4/23/03	Revised 6'x4' Culvert Extension Per Change Order
DATE	REVISION
STATE OF HAWAII DEPARTMENT OF TRANSPORTATION HIGHWAYS DIVISION DRAINAGE PLAN - 1 KAMEHAMEHA HIGHWAY RESURFACING Waiahole Valley Road to Crouching Lion Inn Federal Aid Project No. NH-083-1(43)	
Scale: 1" = 10'	Date: August 1, 2000
SHEET No. C-27 OF 65 SHEETS

KAMEHAMEHA HIGHWAY RESURFACING
Waiahole Valley Road to Crouching Lion Inn
Federal Aid Project No. NH-083-1(43)

FED. ROAD DIST. NO.	STATE	FED. AID PROJ. NO.	FISCAL YEAR	SHEET NO.	TOTAL SHEETS
HAWAII	HAW.	NH-083-1(43)	2001	C.O.34S-1	121

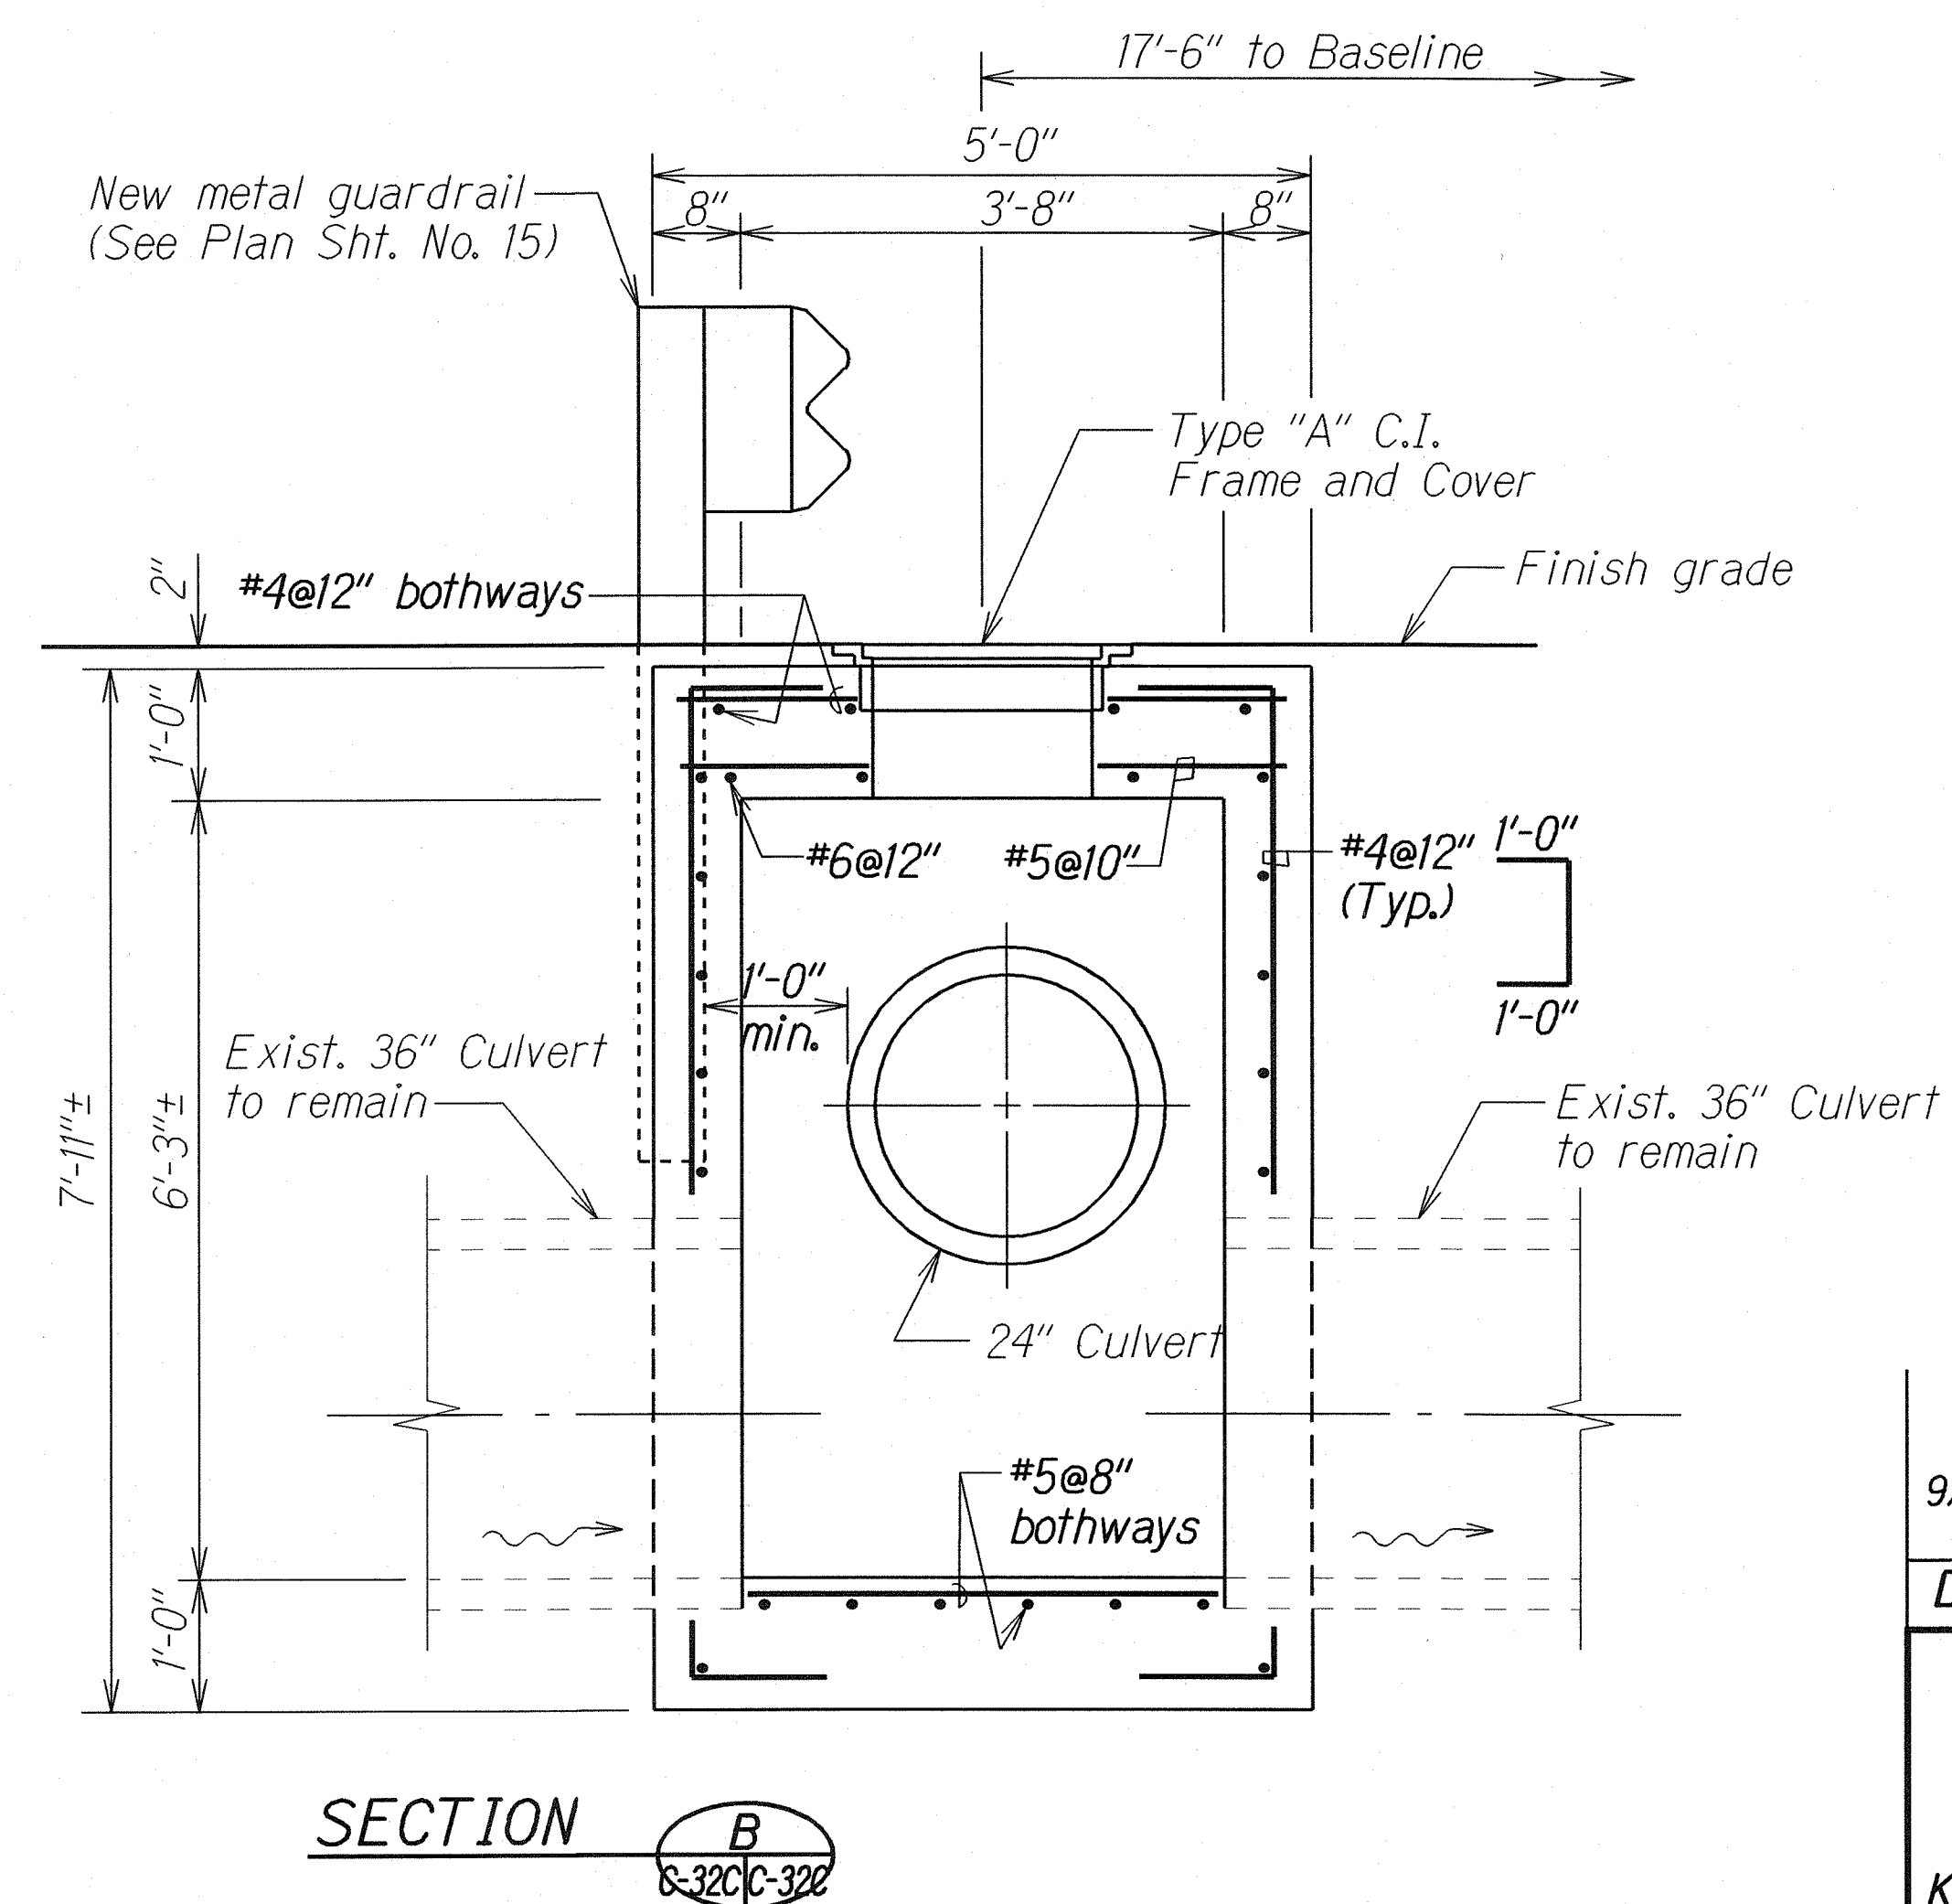
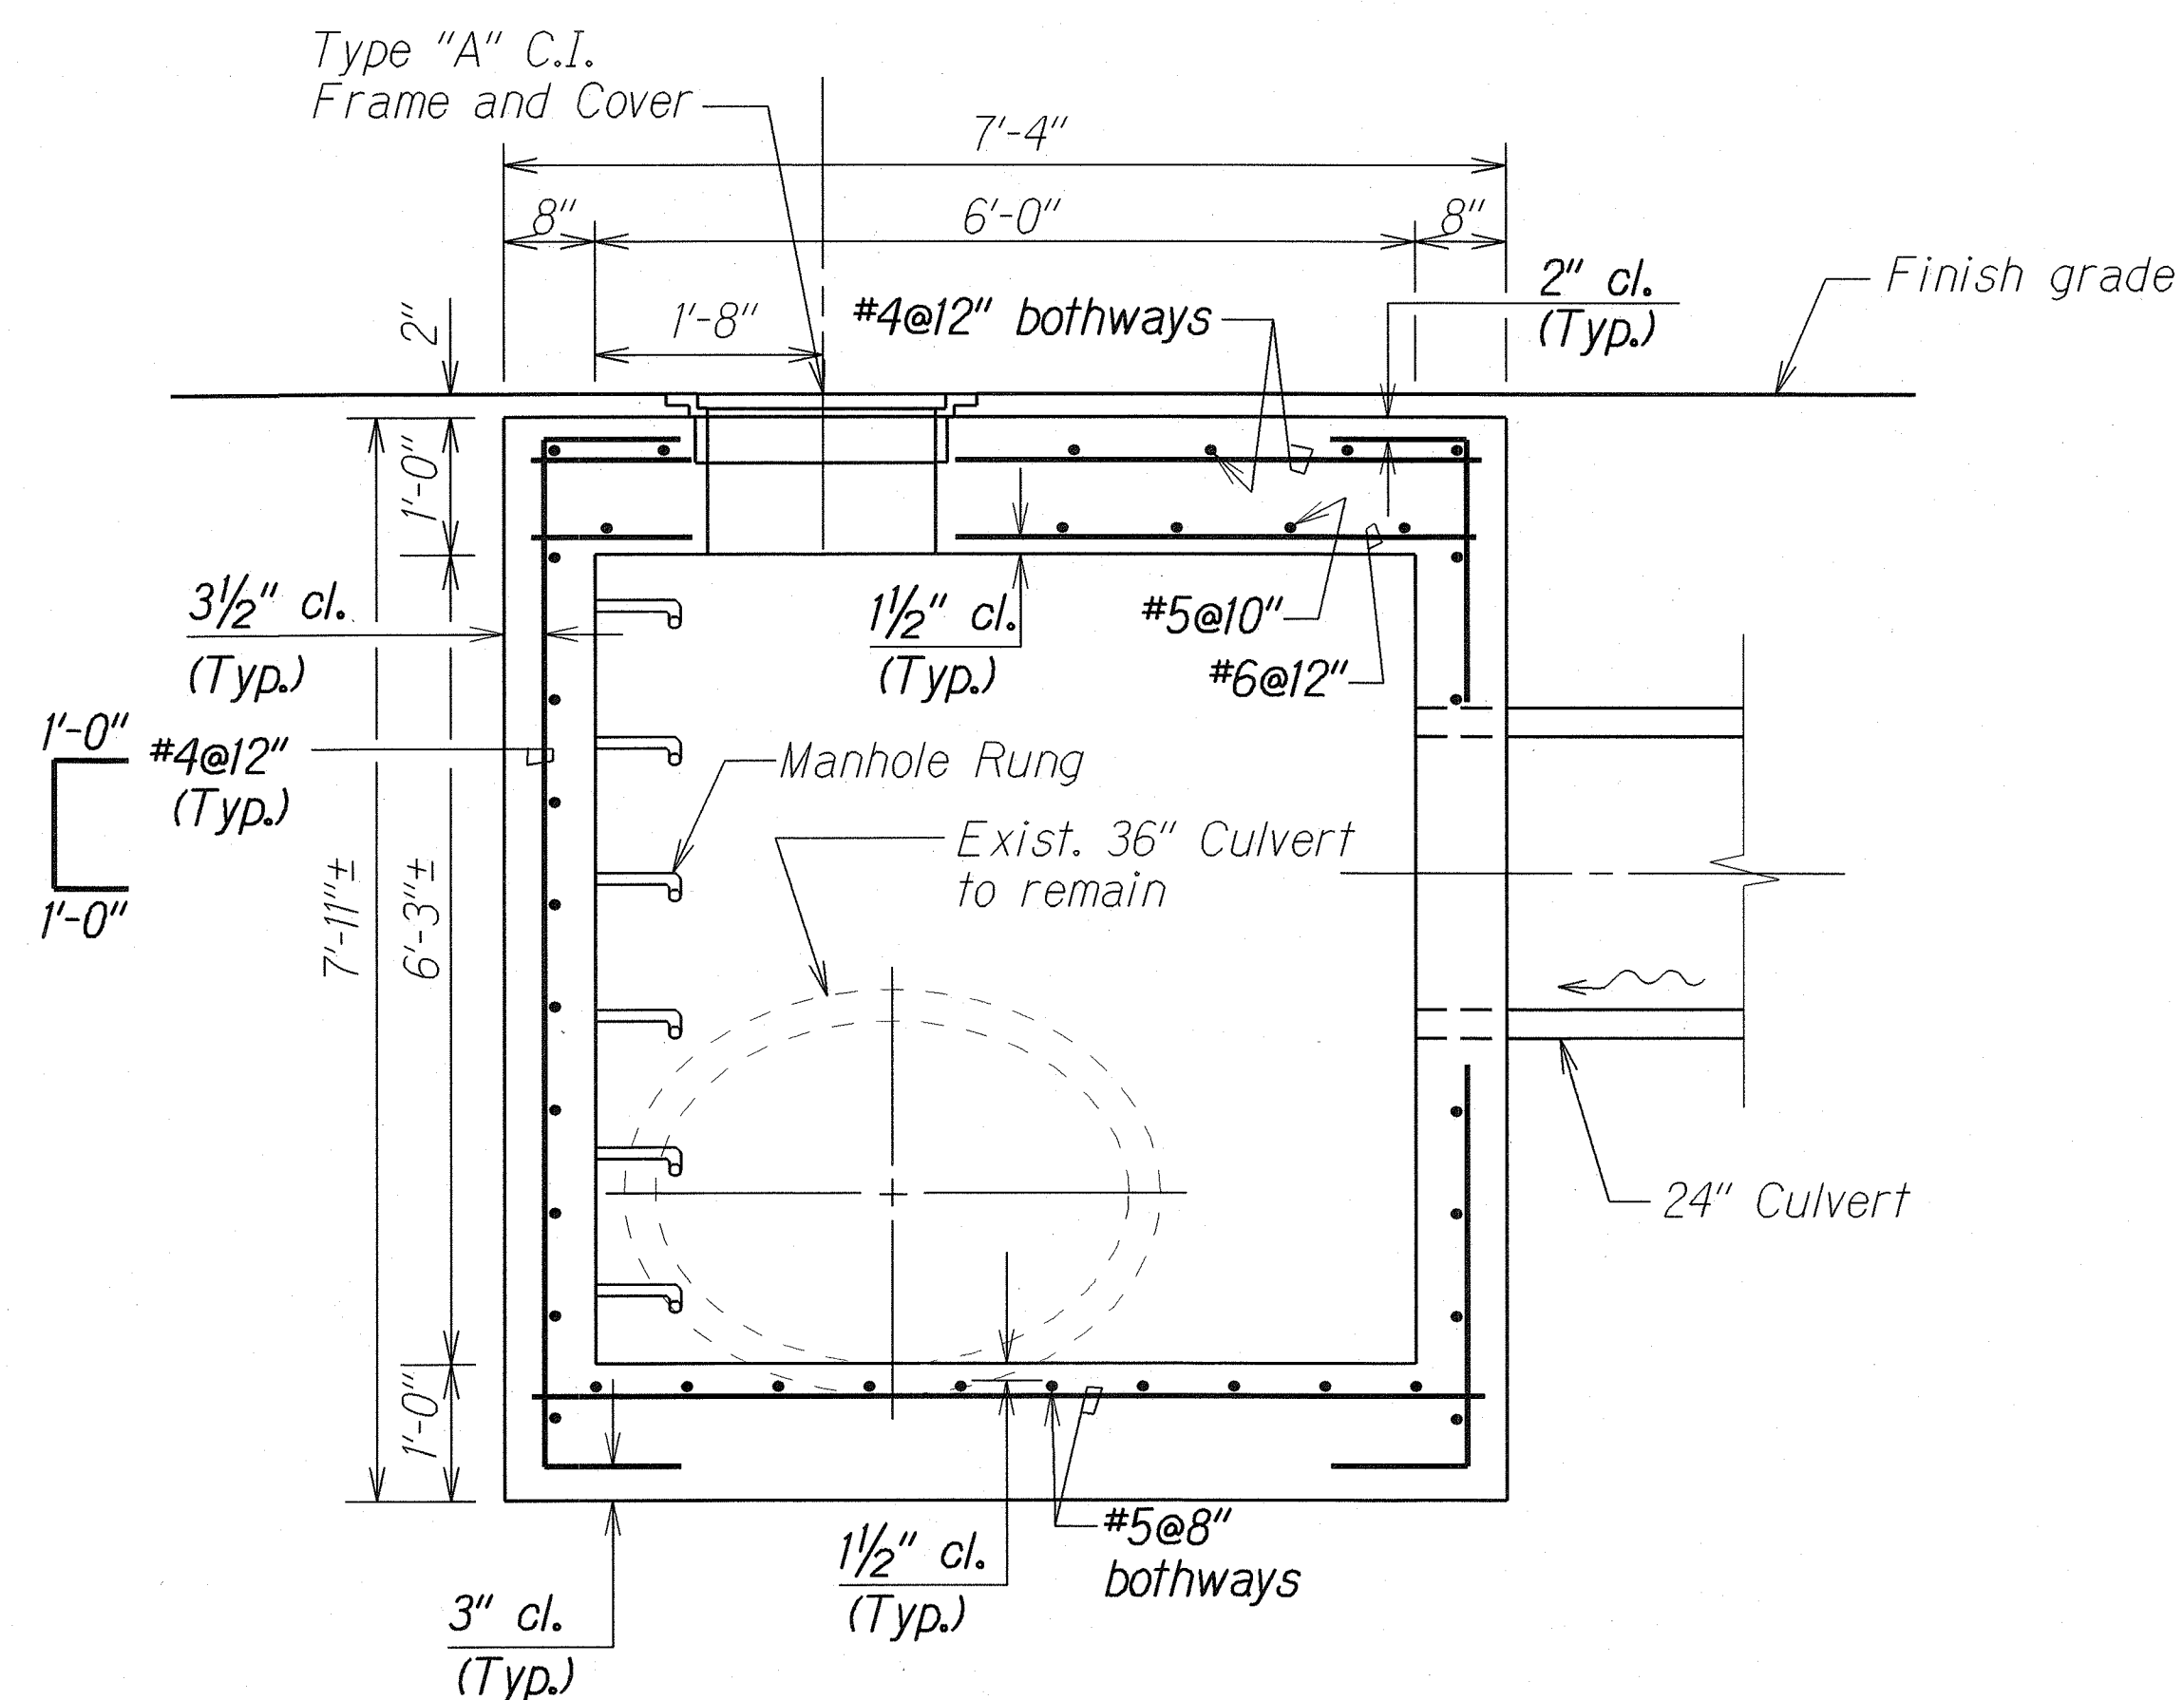
9/3/02	Add detail of Modified Type "C" Storm Drain Manhole.
--------	--
